1 UNITED STATES OF AMERICA
2 NUCLEAR REGULATORY COMMISSION
3 BEFORE THE ATOMIC SAFETY AND LICENSING BOARD
4

5 In the Matter of)
6)
7 STRATA ENERGY, INC.,) Docket No. 40-9091-MLA
8)
9 (Ross *In Situ* Recovery Uranium Project))
10
11
12

13 Pre-Filed Direct Testimony of Dr. Richard Abitz
14 Supporting Joint Intervenors' Contentions 1 and 3
15

- 1 Pourbaix diagrams displaying relevant geochemical conditions from Geochemist
- 2 Workbench®. Top figure shows Iron and bottom figure shows the uranium stability fields.
- 3

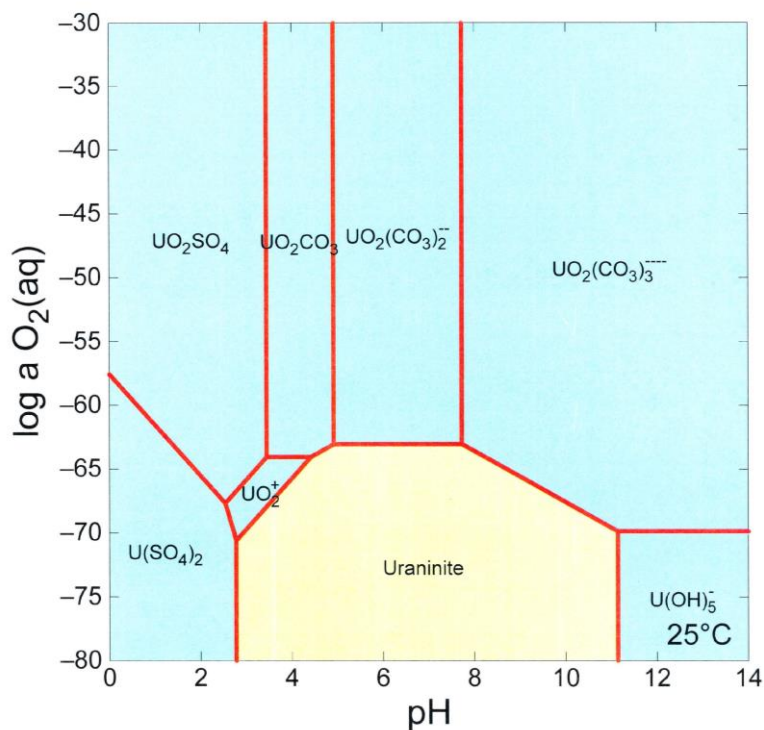
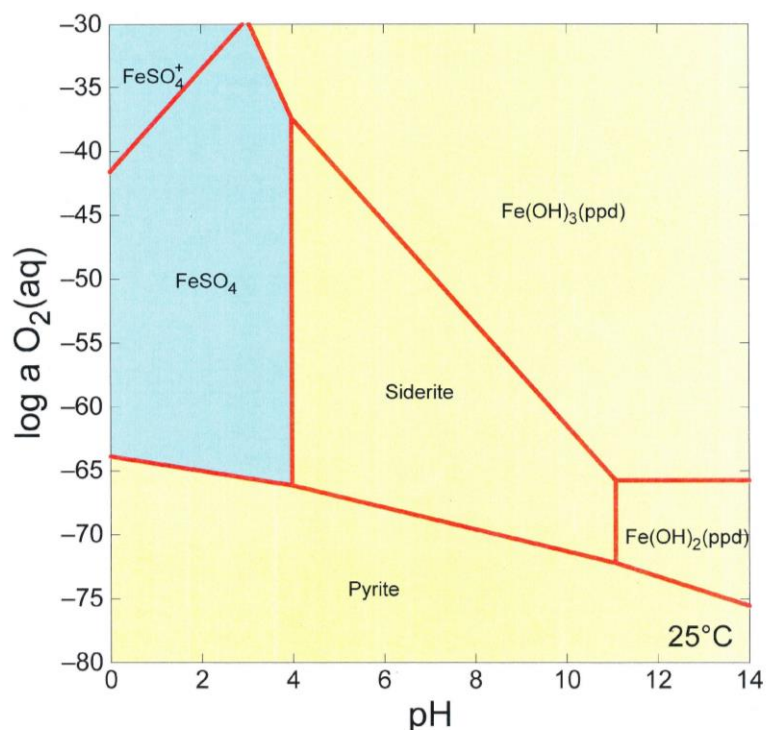
commercial software, such as the Geochemist's Workbench (<http://www.gwb.com/>). I calculated the stability field for pyrite (below figure) using the Geochemist's Workbench and the approximate highest groundwater concentrations for iron (0.57 milligrams/liter), carbonate (610 milligrams/liter) and sulfate (920 milligrams/liter), as reported for the ore zone (Appendix C of FSEIS). The thermodynamic calculations indicate that pyrite is stable over the pH range of 6 to 10 only when oxygen levels are below 1×10^{-65} moles/liter. Next, the uranium concentration in groundwater can be estimated by constraining the uraninite stability field to oxygen levels less than about 1×10^{-65} moles/liter. I constructed this figure (below) using the same water quality data noted above and when the uraninite stability field is below oxygen levels of 1×10^{-65} moles/liter, uranium concentrations in groundwater are less than 1×10^{-10} moles/liter (2.38E-08 grams/liter or 2.38E-14 micrograms liter, which is over 13 orders of magnitude lower than the EPA uranium MCL of 30 micrograms/liter). This analysis shows that the true uranium concentration in groundwater contacting uraninite and pyrite is so low that it cannot be detected with present laboratory methods.

The last criterion in the quoted text under the above bullet states "the accuracy needed to meet study objectives." Given that oxygen levels are extremely low in uranium ore deposits, the well-construction methods must provide the accuracy needed to ensure no oxygen is introduced to the ore zone via drilling fluids and compressed atmospheric air.

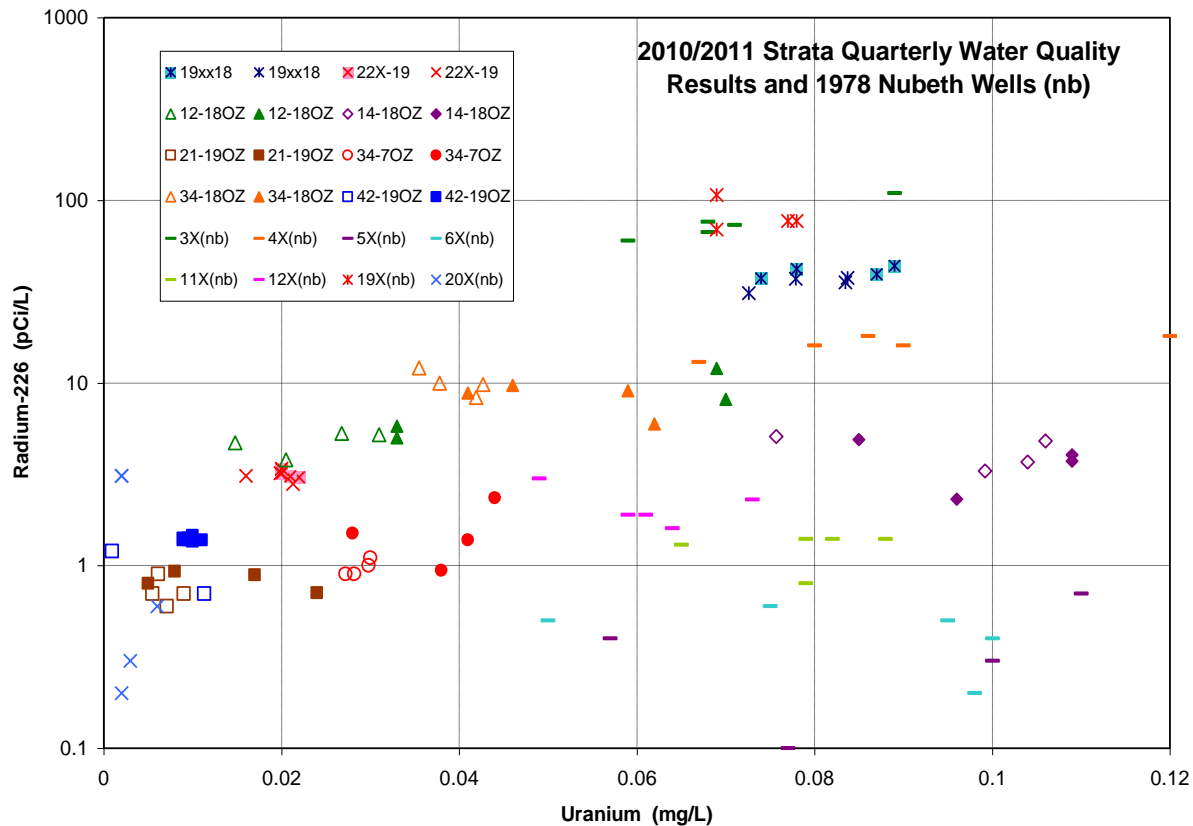
14 In Appendix C of the FSEIS, the 2011 data are tabulated and it is a fundamental failure of
15 the analysis in the FSEIS that it nowhere confronts the significance of the 2011 results relative to
16 the 2010 values. I have plotted the 2011 and 2010 radium-226 and uranium results (below
17 figure) reported in Appendix C and the Nubeth 'baseline' data to reveal the trends that support
18 our conclusions on the anthropogenic degradation of water-quality parameters from mechanical
19 and chemical disturbance of the ore zone during drilling operations and well development before
20 the license has been issued. I will discuss the Strata wells first and refer to the Nubeth wells later
21 in this testimony.

1 The 2011 ore-zone data for Strata's six regional wells (open symbols on the figure) show
2 uranium has decreased in 4 of the 6 wells (12-18, 21-19, 34-07, 34-18) and radium-226 is
3 essentially unchanged, relative to the 2010 data (filled symbols). Uranium decreases over this
4 time interval as the aquifer begins to return to reducing conditions following the initial
5 disturbance and oxidation of the uranium ore when the wells were installed and developed.
6 Radium-226 remains at the 2010 levels as radium is insensitive to redox changes once it is
7 released from the uranium bearing ore. The initial magnitude of disturbance and oxidation of the
8 uranium ore varies from location to location, as it is dependent on the time spent in developing
9 the well with air lift and jetting techniques. For well 14-18, the similar results for 2010 and 2011
10 indicate the ore zone may have been disturbed for a longer period of time during well

11 development. Importantly, the trends for uranium and radium-226 show that the ore zone is
12 disturbed and oxidized by well installation and development activities and it is inaccurate of the
13 NRC Staff to assert that a true baseline can be developed after hundreds to thousands of wells are

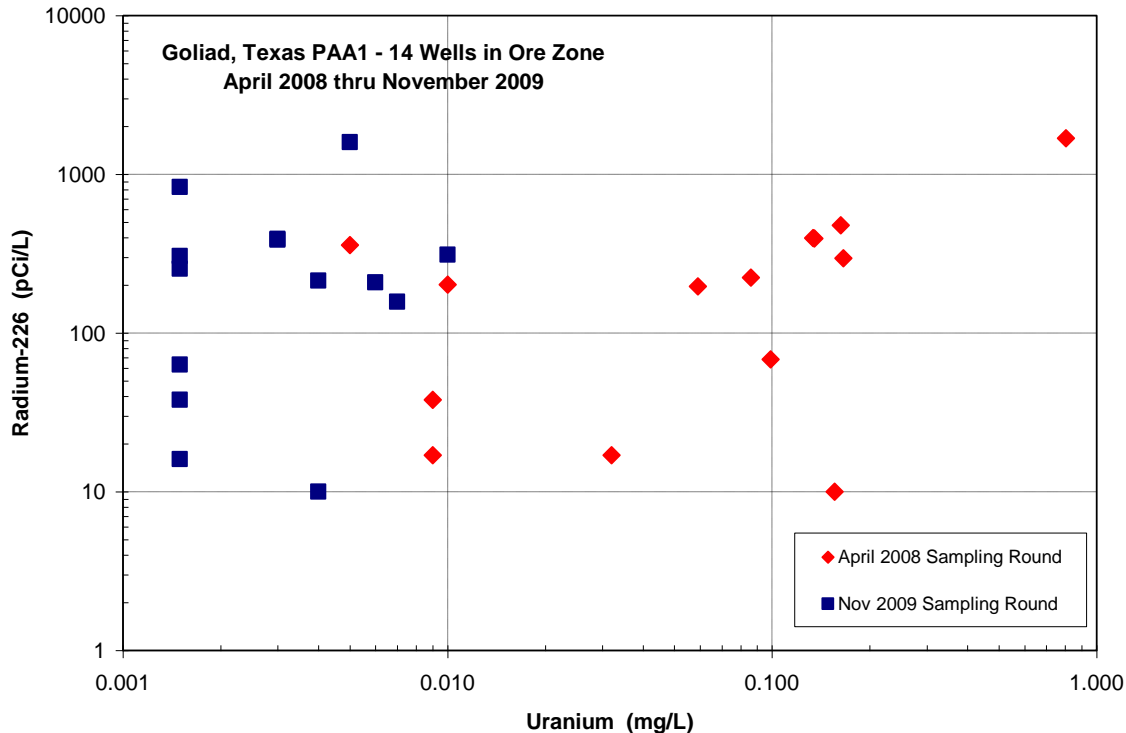
11 Table 5.2 and JTI016, 2009 updates). Again I plotted the uranium and radium results for the site

1 (see figure on next page). Installation of the production wells was performed with improper
2 methods and anthropogenic oxidation of the ore body was captured by the first sampling round
3 in April through September of 2008 (red diamonds in below figure). Fourteen months later,
4 another sampling round was collected in November 2009 for the same wells and all uranium
5 levels had fallen below the EPA uranium MCL of 0.03 mg/L (blue squares); most decreasing by
6 at least an order of magnitude. Again, once the ore body is oxidized during well installation, the
7 radium-226 released from the uranium ore will not drop out of solution because it is insensitive
8 to redox changes. Therefore, allowing improper well installation methods results in
9 contamination of the groundwater prior to any mining activity taking place and the ISL industry
10 'baseline' values are invalid for uranium, radium-226 and other contaminants associated with the

¹ Baseline for Kingsville Dome Production Area Authorization (PAA) 1 and PAA 2 were established two years apart and much higher values were measured for PAA2 (invalid average values - PAA1: uranium = 0.164 mg/L; radium-226 = 22 pCi/L. PAA2: uranium = 1.89 mg/L; radium-226 = 92 pCi/L).

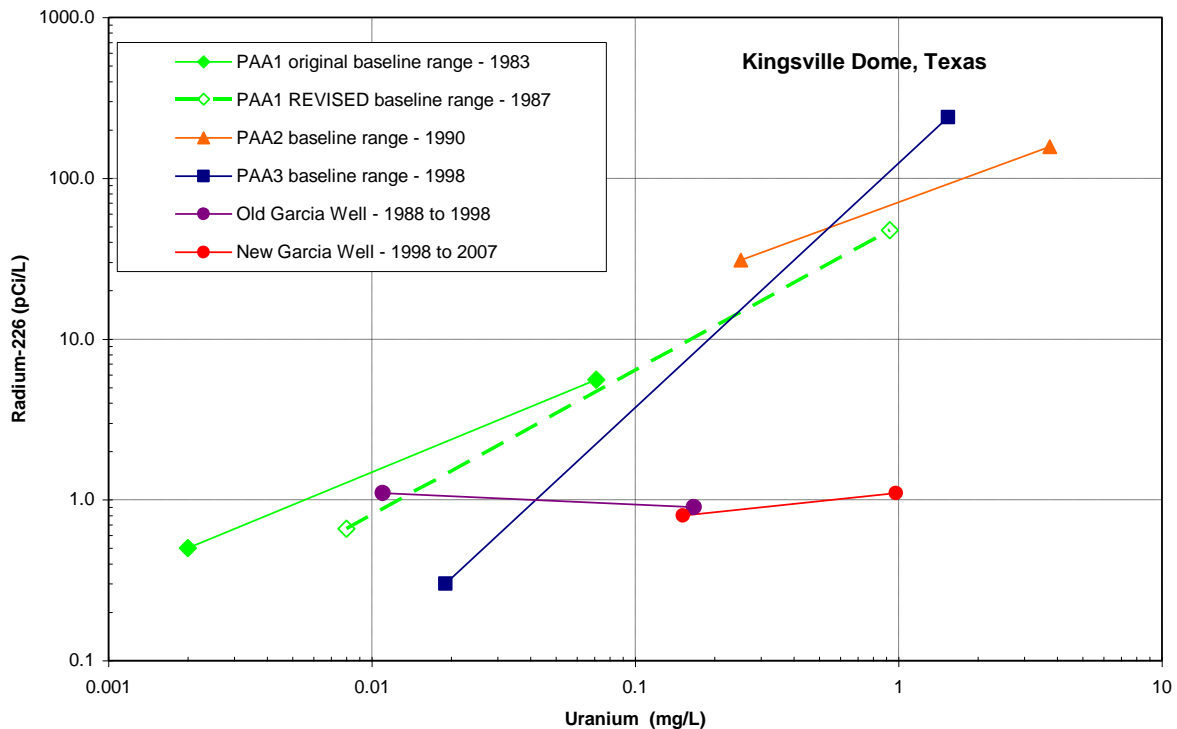
1 allow post-licensing, pre-operational 'baseline' for each well field as it is built. I created a chart
2 that can be found below to illustrate these concerns.

3 In August 1983, the initial PAA1 'baseline' was established after the installation of
4 production wells in the ore zone (JTI019, Table 2.7-4 from URI 1983c), and the ranges for
5 uranium and radium-226 for this invalid 'baseline' are shown by the solid green diamonds and
6 bold green line on the below figure. After additional well fields were built out, the Texas Water
7 Commission (JTI017, TWC 1988, p.10) [TWC is now the Texas Commission on Environmental
8 Quality (TCEQ)] allowed the operator to revise the 'baseline' for PAA1 in November 1987
9 (open green diamonds and fine green line on the figure). In doing so, TWC allowed the operator
10 to increase the 'baseline' for both uranium and radium-226 by using maximum values that were
11 approximately ten times higher relative to the initial 'baseline' established in 1983.

12 In February 1990, after mining at PAA1 for approximately 6.5 years, TWC (JTI018,
13 1990, p.9) allowed the operator to establish 'baseline' values at the adjacent PAA2 (solid orange
14 triangles and orange line on the figure), which is located downgradient from the ISL operations
15 in PAA1. This TCEQ action allowed the operator to elevate the uranium 'baseline' value using a
16 maximum value (3.8 mg/L) that is 100 times higher than the maximum uranium value (0.071
17 mg/L) used to calculate the initial PAA1 'baseline'. Proceeding to PAA3, TWC (JTI020, 2006,
18 p.12) allowed the operator to establish 'baseline' in June of 1998, nearly fifteen years after
19 mining began in PAA1. Therefore, the record at Kingsville Dome clearly shows the
20 deterioration of the nominal invalid 'baseline' values with time when the operator is allowed to
21 develop the 'baseline' for each unit as the well fields are built out.

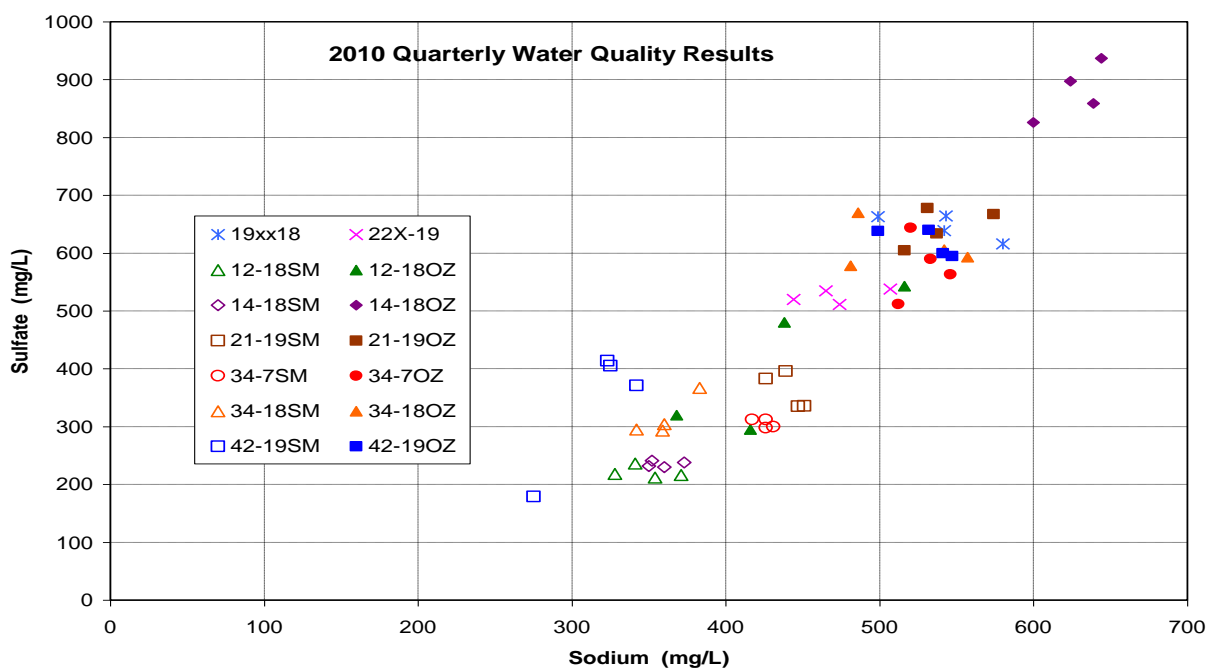
A. 44. Demonstration of adequate hydrologic control is not a trivial matter because groundwater communication between the SM and OZ horizons is evident in the 24-hour pump test data from well 12-18OZ and the water-quality results for sodium and sulfate (see my figure below,

constructed from data in Appendix C of the FSEIS (SEI009A). Groundwater from the ore horizon (OZ; solid symbols) generally has higher sodium and sulfate, relative to the overlying groundwater (SM). However, mixing of the groundwater from these two horizons is clearly indicated by the linear trace of the sodium and sulfate trend on Figure 2. In my expert opinion, this is unquestionably demonstrated by the mid-location of plotted samples from 22X-19, a well that is screened through the OZ and SM zones (SEI006A, Section 2.7.3.3.1, p.2-169, Strata TR). If 14-18OZ is taken as the unmixed groundwater from the ore horizon, all other OZ samples are shown to have a component of SM water, as they lie between 14-18OZ and 22x-19. Note that the strong mixing between the horizons is unequivocal for samples from 12-18OZ, which plot with the samples from 22x-19 and the SM horizon.

4 A. 45. The above figure illustrates that the closer a pair of samples plots for a given cluster well
5 (e.g., 12-18SM and 12-18OZ), the higher the probability for groundwater contamination by
6 communication between the two groundwater zones during ISL operations. In contrast to mixing
7 between the 12-18 horizons, 14-18SM and 14-18OZ samples cluster tightly and are well
8 separated on the plot. An explanation for the distinct separation of the 14-18 horizons on the
9 sodium-sulfate plot may be that the density of exploration boreholes is lower around this cluster
10 well and less communication between the SM and OZ horizons has occurred (*i.e.*, 14-18 may
11 provide a snapshot of the distinct major-ion chemistry of the horizons prior to the drilling of
12 thousands of exploration boreholes).

Fig. 2.8. Alternate interpretations of the same borehole data.

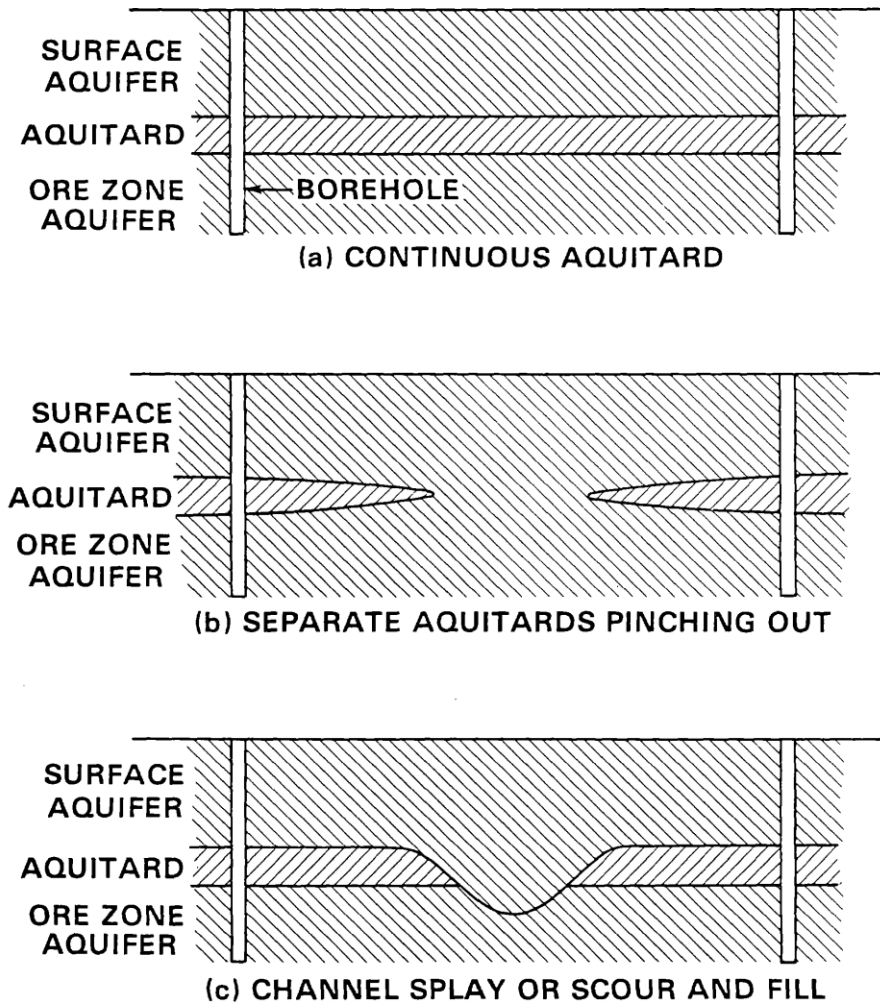
1 A. 46. Yes. The above analysis is supported by the discussion and figure from (Staub et al.1986;
2 NRC020 at p. 24), which provides evidence for alternative interpretations to aquifer tests and the
3 complexities in adequately defining aquifer confinement:

4 *“Conventional exploration methods as describe above seldom*
5 *provide enough detail to determine whether an ore zone aquifer is*
6 *sufficiently isolated from other aquifers. The complex stratigraphy*
7 *of alluvial sediments is a serious obstacle to projection of*
8 *lithologic units between boreholes even at short distances. Figure*
9 *2.8 [original document; see below] presents several*
10 *interpretations of the same data. In the absence of proof of the*
11 *contrary, stratigraphic units are often projected as continuous*
12 *layers between boreholes which may lead to a false sense of*
13 *security with respect to aquifer isolation. Furthermore, two-*
14 *dimensional cross-sections do not necessarily portray accurate*
15 *relationships between aquifers in three dimensions. Thus, an*
16 *aquitard may be continuous in one direction and discontinuous in*
17 *another.” (Staub et al. 1986) (page 24).*
